V1_Letter of Intent_COMMENTS.pdf Markup Summary

Re: Letter Of Intent – Site Development Plan for 6155 Fountain Valley Schools

PCD File: ~~PPR-07-030~~

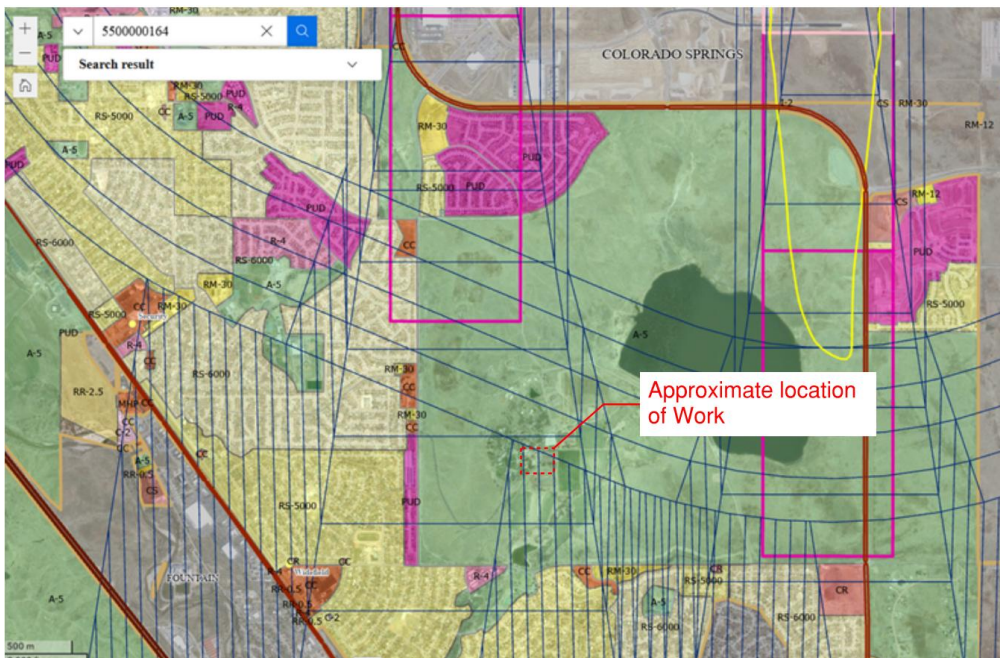
El Paso County Enumerations assigned the two new building addresses as follows: **6300 Fountain Valley School Rd (STEM Building)** which is located to the north and denoted with a "3" in the screenshot below, and **6155 Fountain Valley School Rd (Humanities Building)** which is located to the south and denoted with a "2".

See PPRBD comment in EDARP. New address for this building will be 6330 Fountain Valley School Rd.

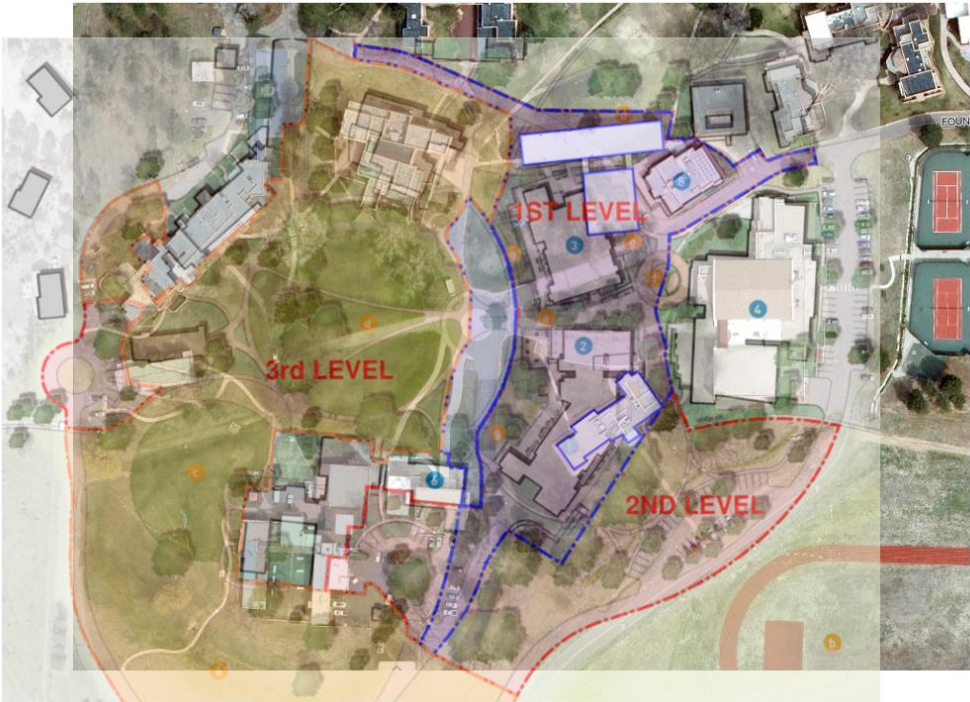
Discuss the total GSF (all floors) of the buildings to be demo'd and the total GSF of new building to be constructed.
